Addendum #2 – Issued December 3, 2012

Regarding Bids for **Engineer Road Maintenance Building – MEP, Fire Protection, General Trades & Fueling System (ITB 12-032P)** for Lucas County Engineer Road Maintenance, bid opening scheduled for December 6, 2012 at 2:00 P.M. (local time).

ADDENDUM NO. 02

Lucas County Road Maintenance Building
Bid Package #12-032P – Plumbing, Mechanical, Electrical, Fire Protection,
General Trades and Fueling Station Packages
Dated 12/3/2012

OVERALL SITE PLAN – ELECTRICAL

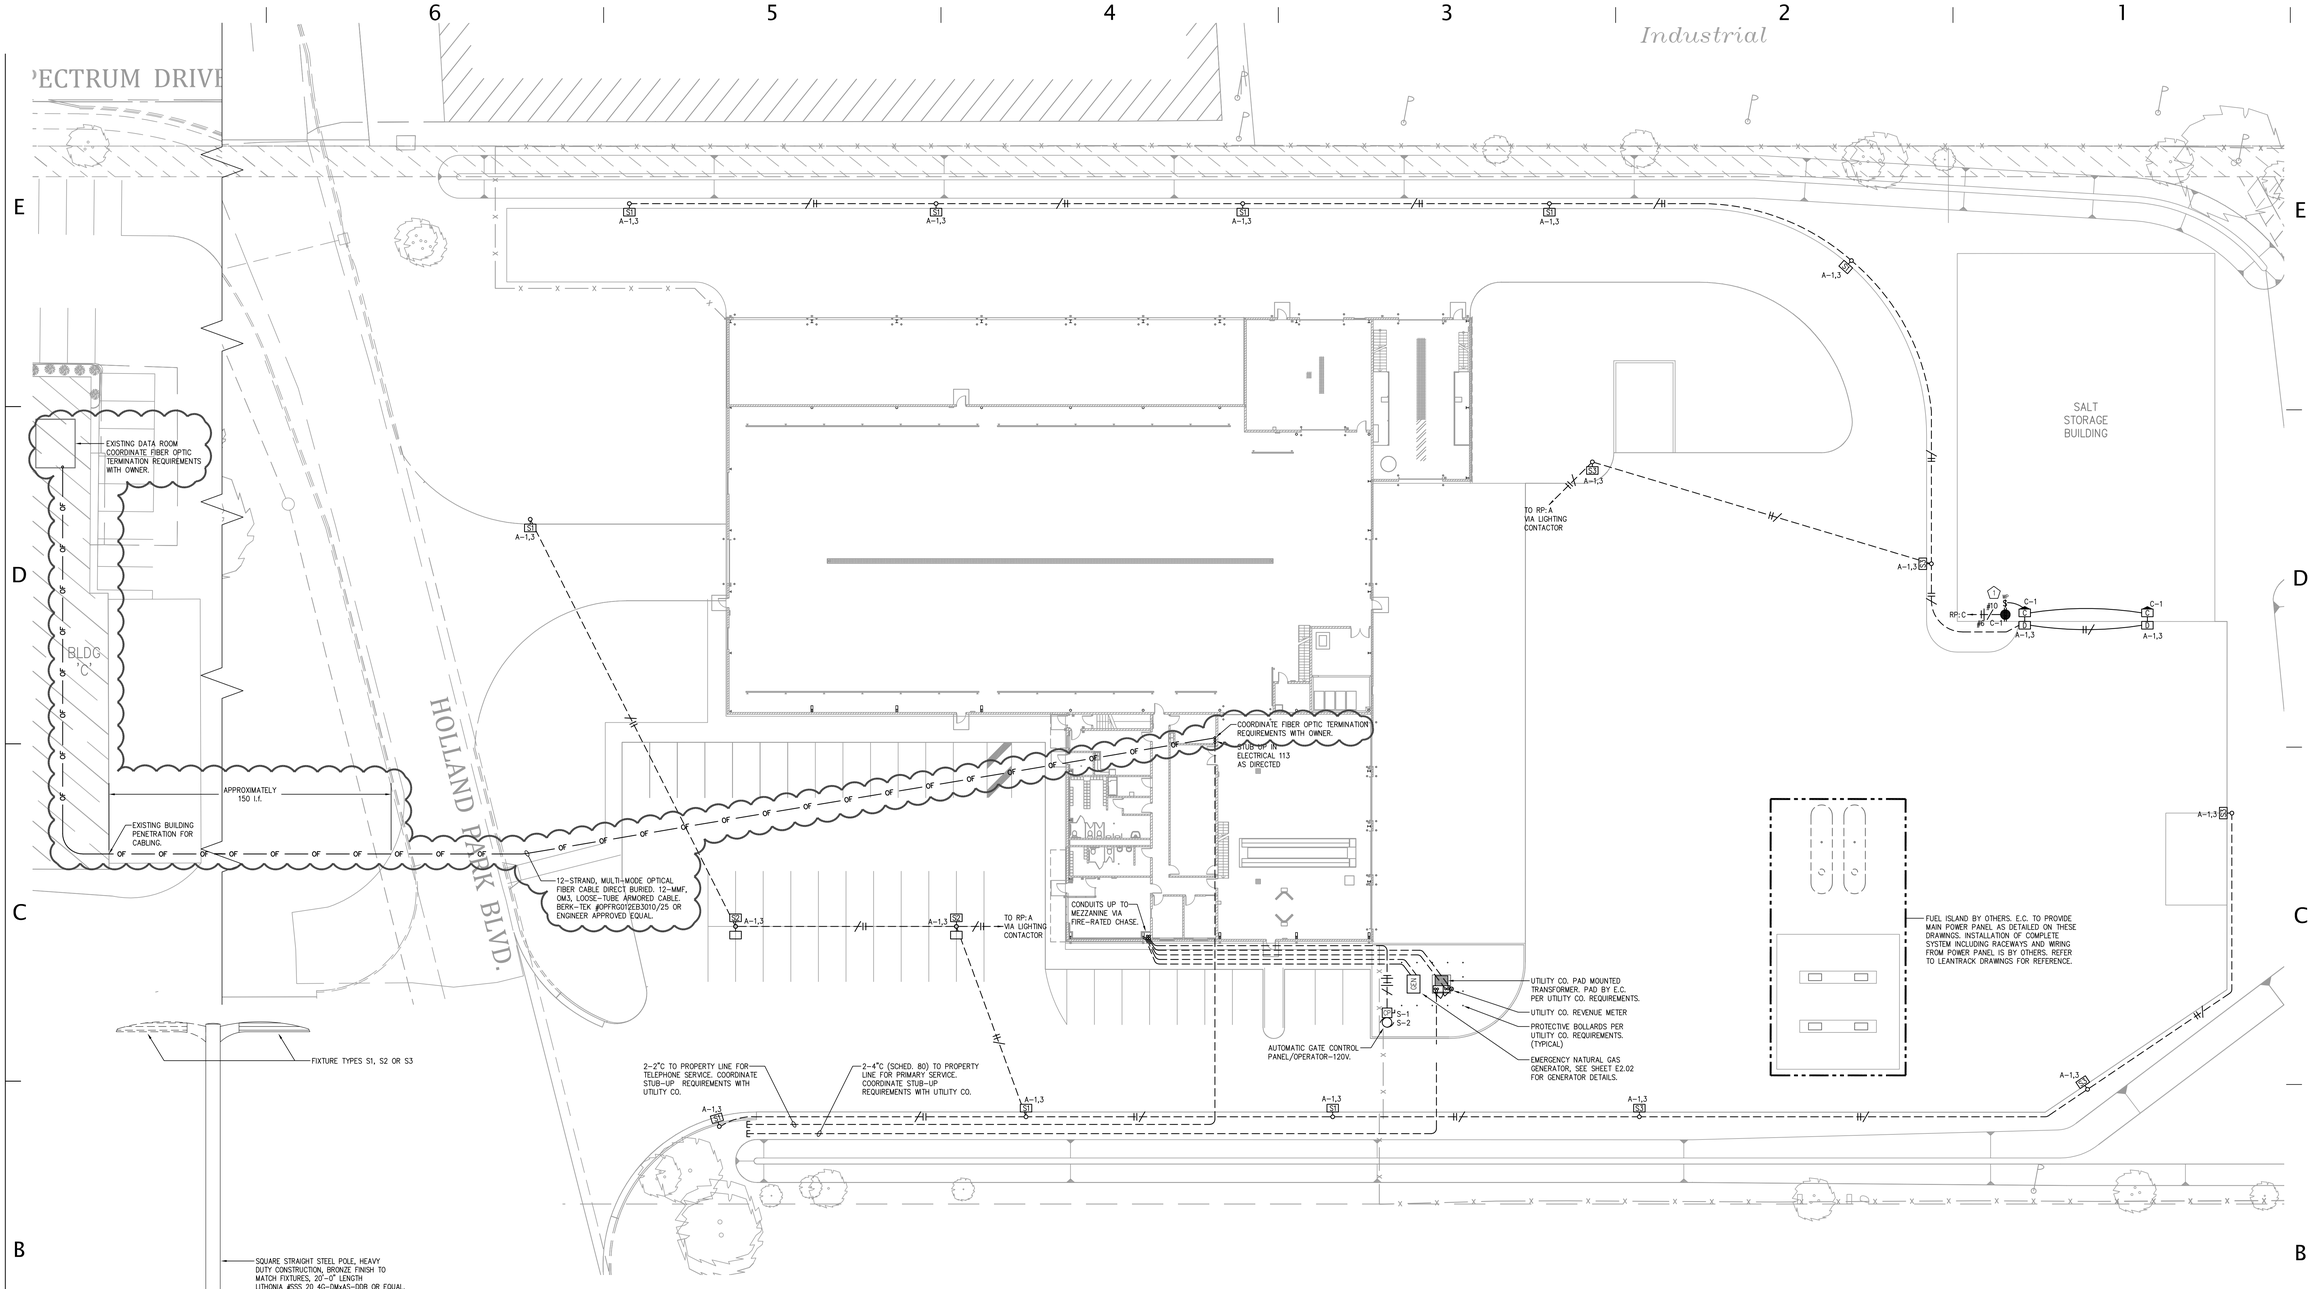
Drawing E1.01 Overall Site Plan - Electrical (drawing reissued):
Item #1 Added direct-buried optical fiber cabling from existing Building C.

FIRST FLOOR PLAN – POWER

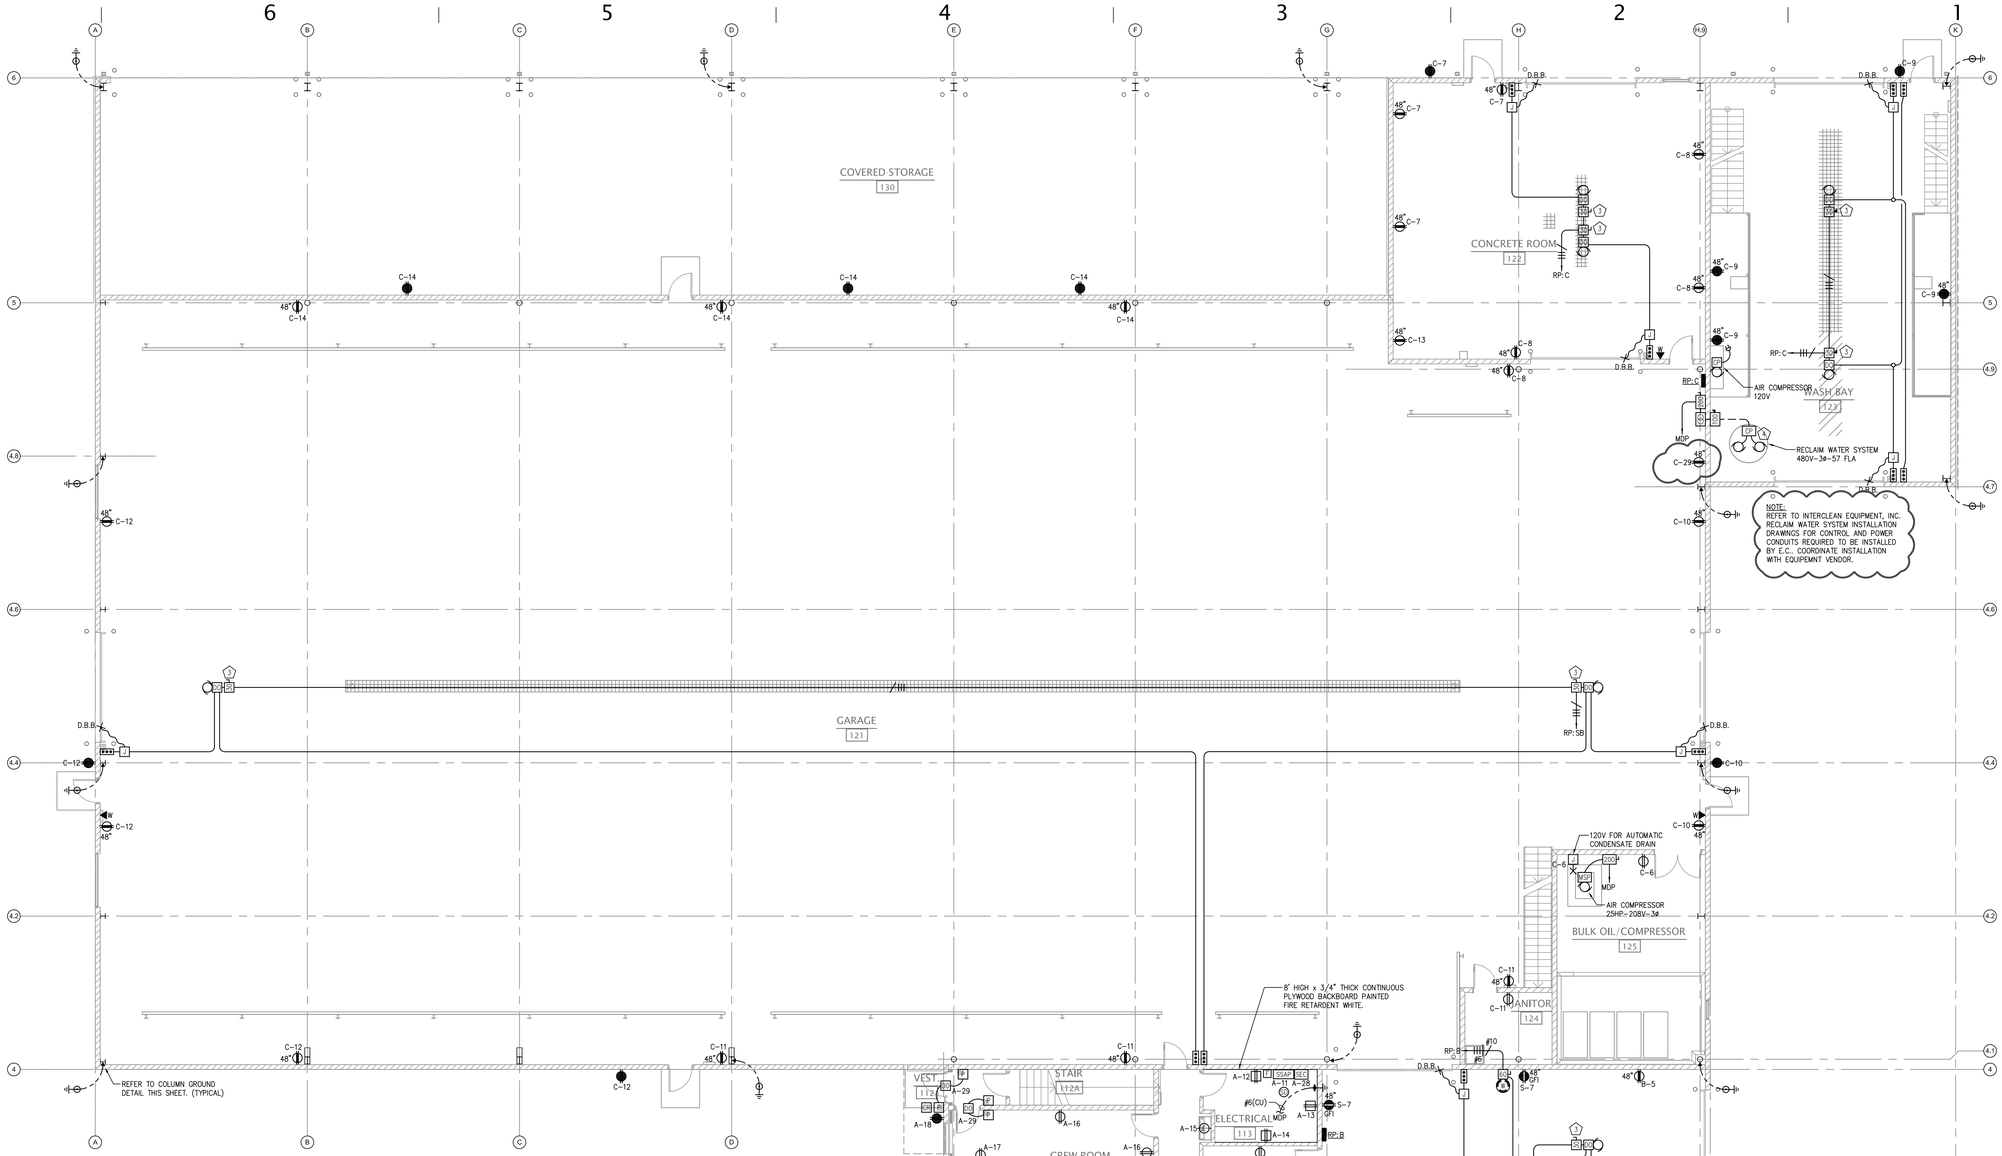
Drawing E3.01 First Floor Plan - Power (drawing reissued):
Item #1 Added receptacle for owner provided ice machine.

Item #2 Added note for E.C. required conduit at reclaim water system.
Item #3 Added disconnect and branch circuit for dry-pipe system air compressor.

E5.01

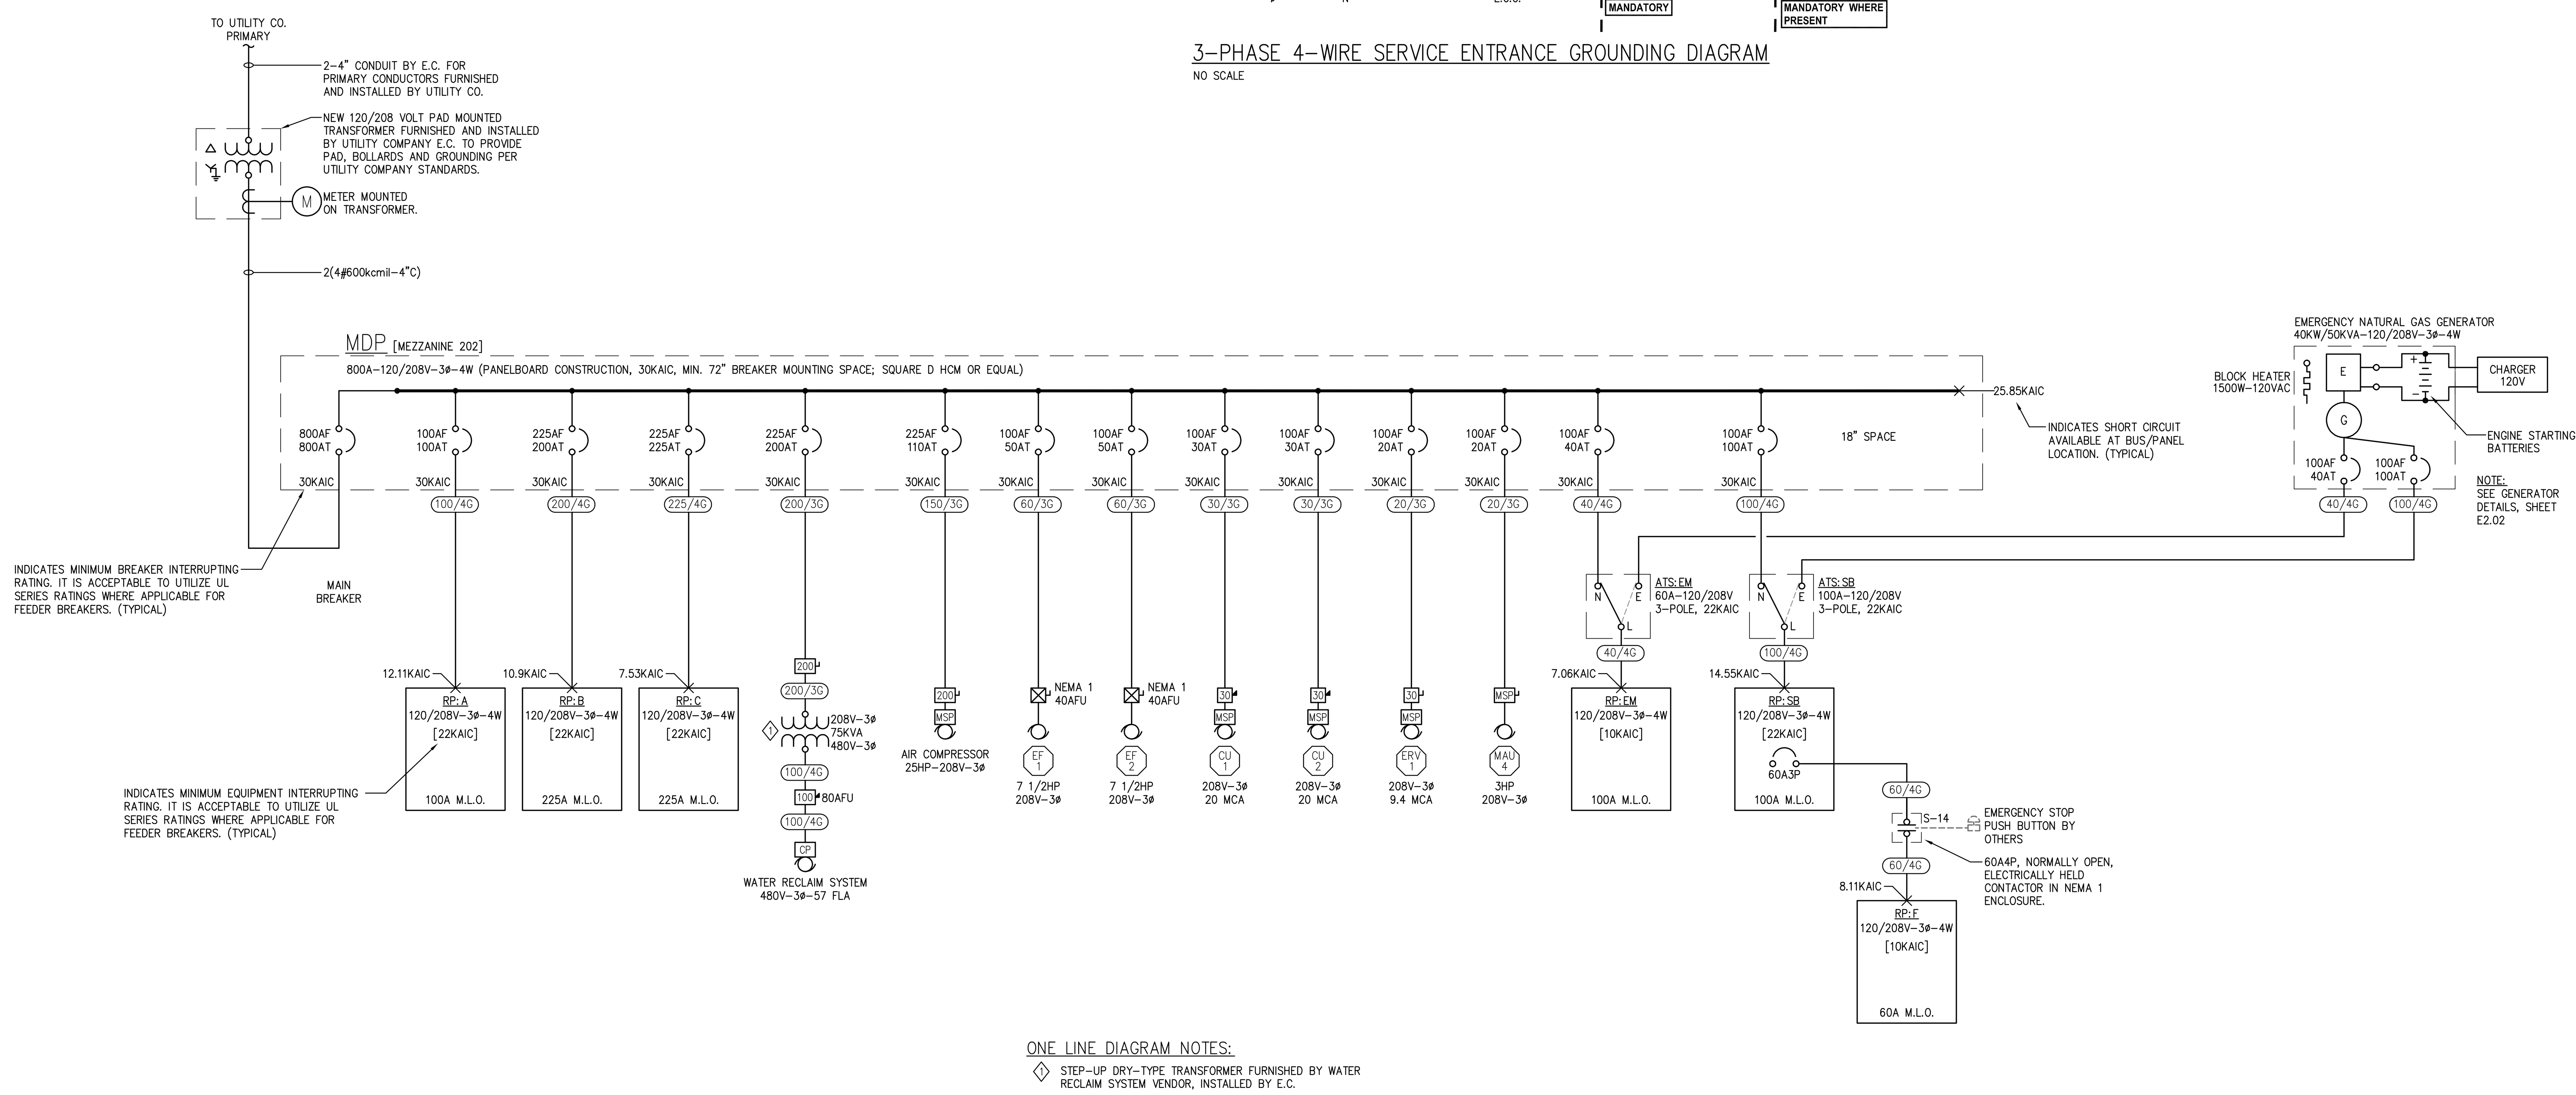
Drawing E5.01 One Line Diagram and Panel Schedules (drawing reissued):
Item #1 Revised panel schedules RP:A and RP:C.

P1.03

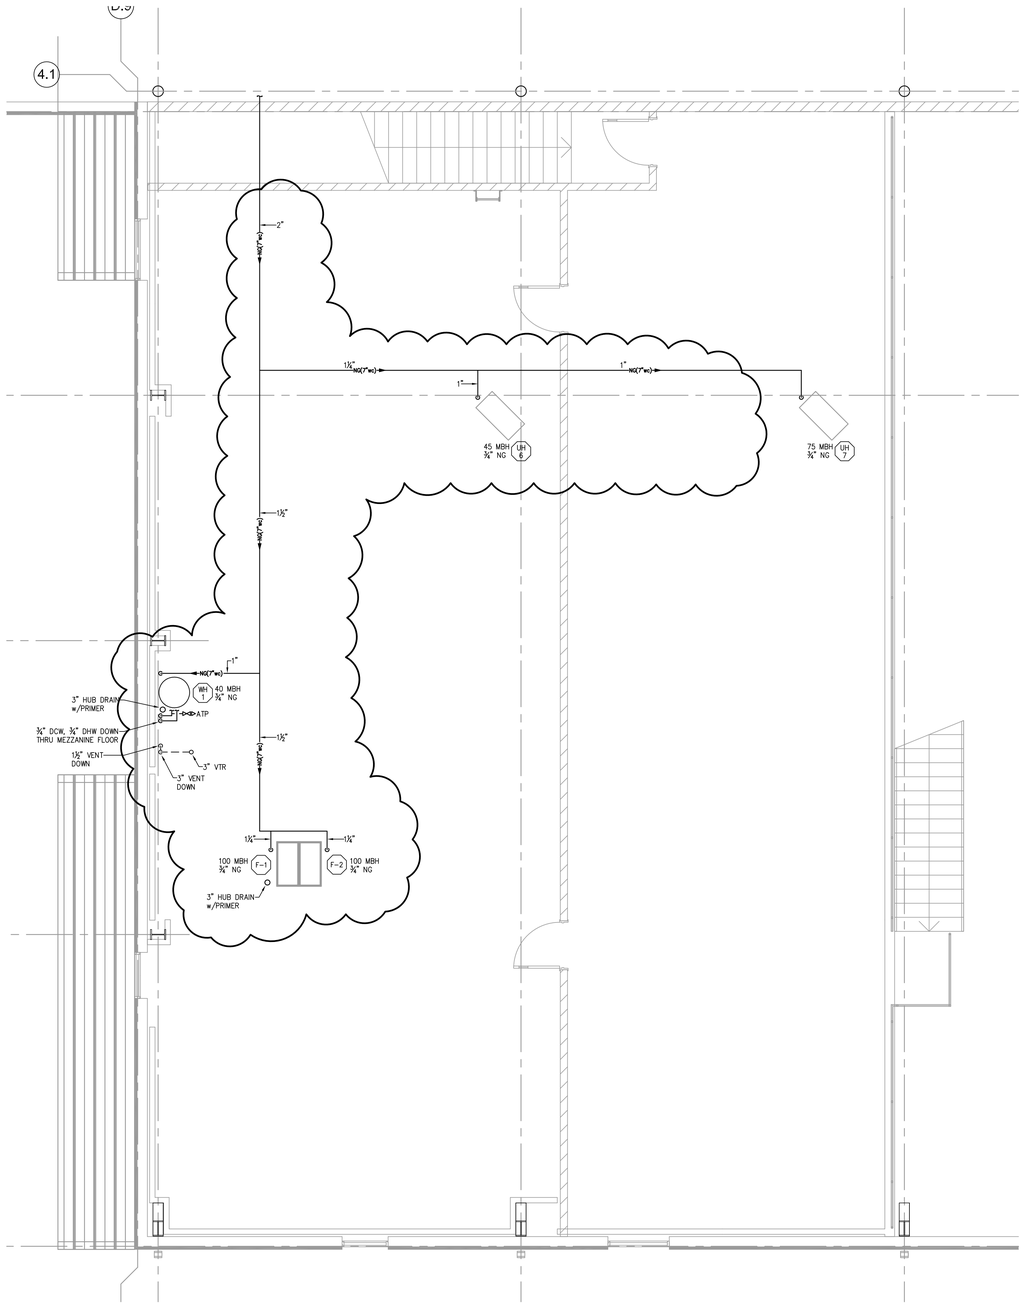
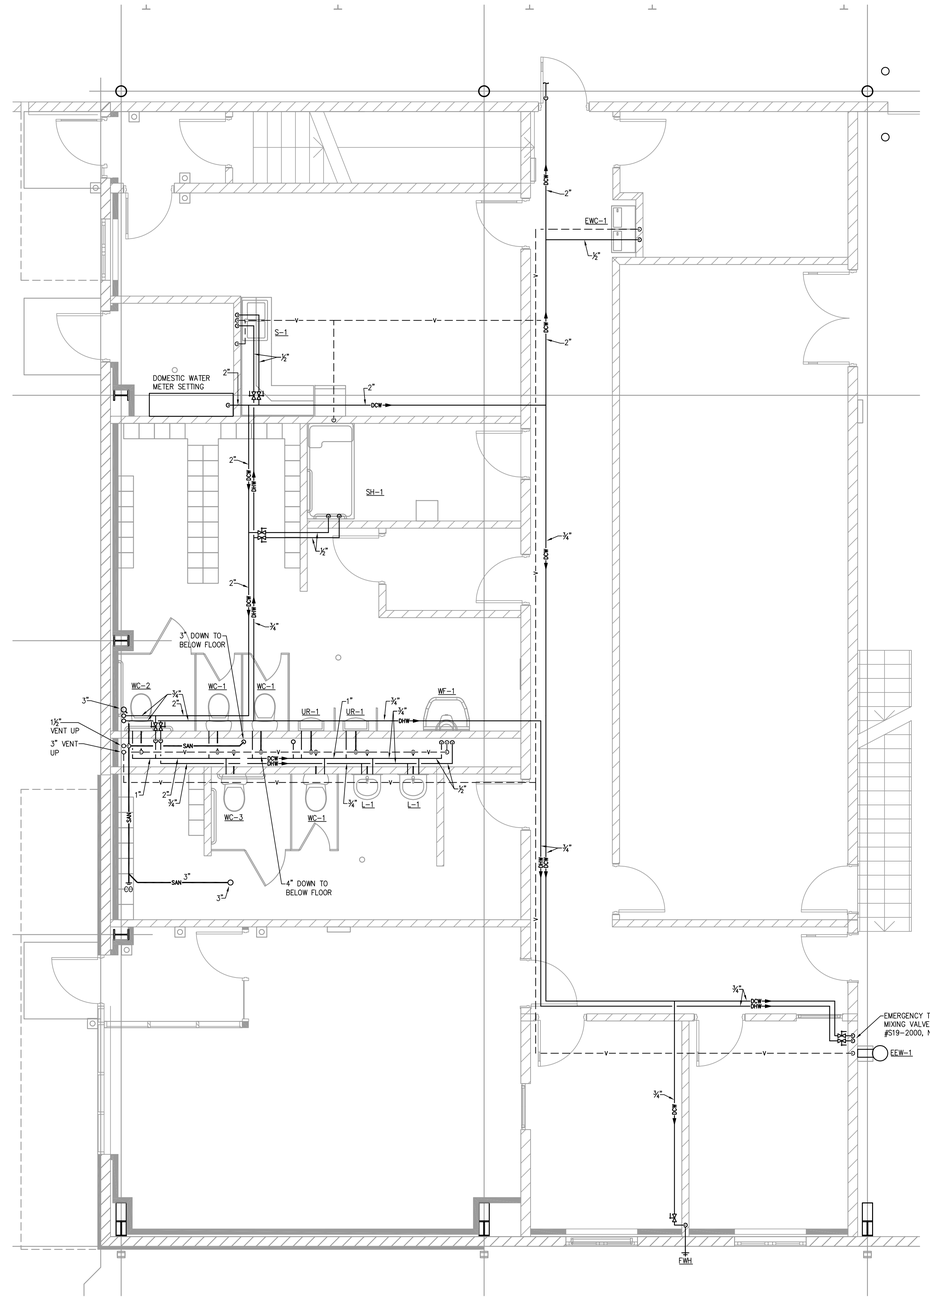
Drawing P1.03 Enlarged First Floor Plan – Plumbing (drawing reissued):
Item #1 Revise gas piping sizes. Gas piping sized @ 7”wc, 2 psi not available.
